14-16 MARLOW STREET

RE: 16 Marlow Street

Your application to construct a 12' X 12' dormer has been reviewed and a building permit is herewith issued subject to the following requirement:

CONSTRUCTION NOTES

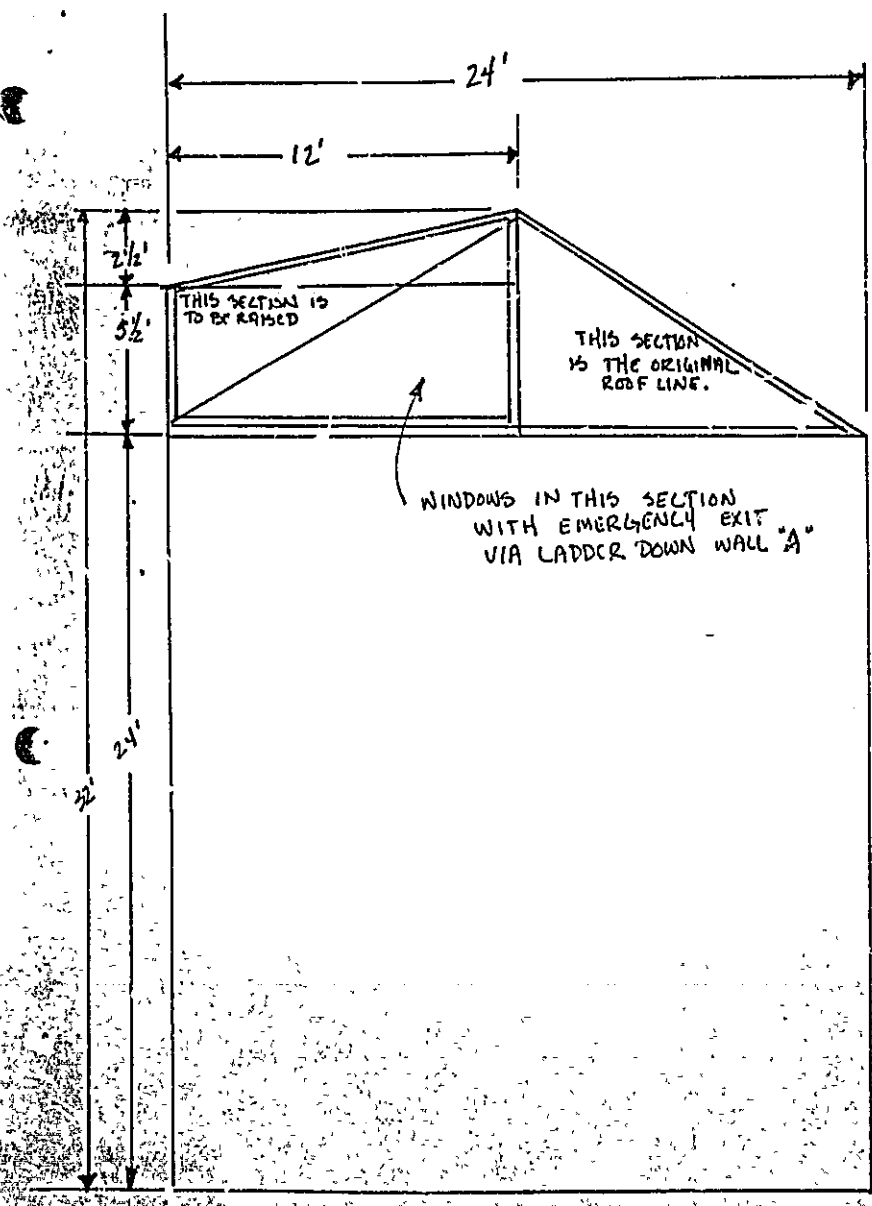
Your plan shows 2" X 6" rafters 16" o.c. 2" X 8" rafters 16" o.c. must be used.
